PROPOSED CHANGE RTS-269 TO THE DUANE ARNOLD ENERGY CENTER
TECHNICAL SPECIFICATIONS

The holders of license DPR-49 for the Duane Arnold Energy Center propose to amend Appendix A (Technical Specifications) to said license by deleting certain current pages and replacing them with the attached, new pages. The List of Affected Pages is given below.

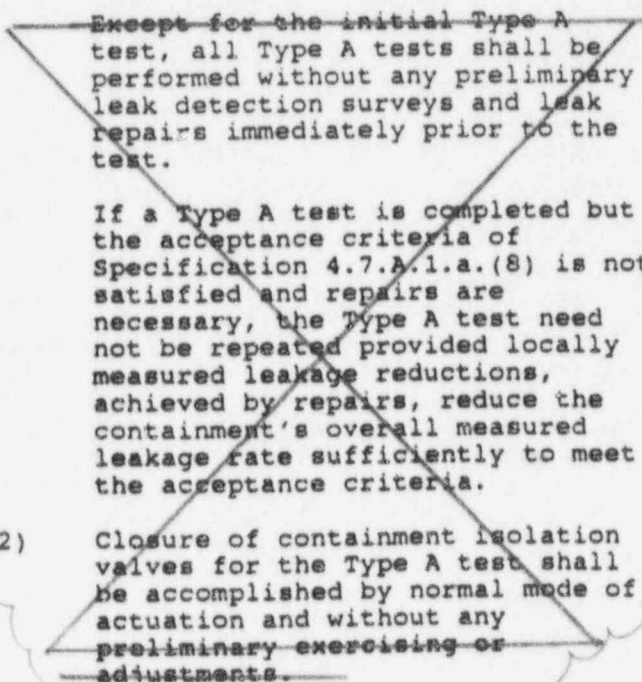
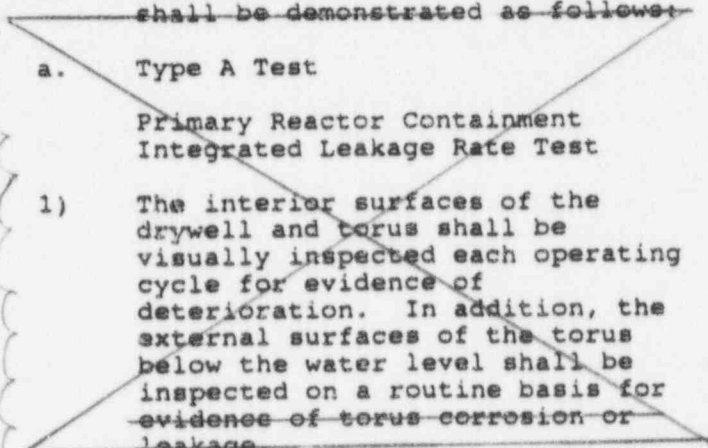
1. ~~PRIMARY CONTAINMENT INTEGRITY shall be demonstrated as follows:~~

INSERT A

Except for the initial Type A test, all Type A tests shall be performed without any preliminary leak detection surveys and leak repairs immediately prior to the test.

If a Type A test is completed but the acceptance criteria of Specification 4.7.A.1.a.(8) is not satisfied and repairs are necessary, the Type A test need not be repeated provided locally measured leakage reductions, achieved by repairs, reduce the containment's overall measured leakage rate sufficiently to meet the acceptance criteria.

- a. Perform required visual examinations and leakage rate testing in accordance with the Primary Containment Leakage Rate Testing Program.
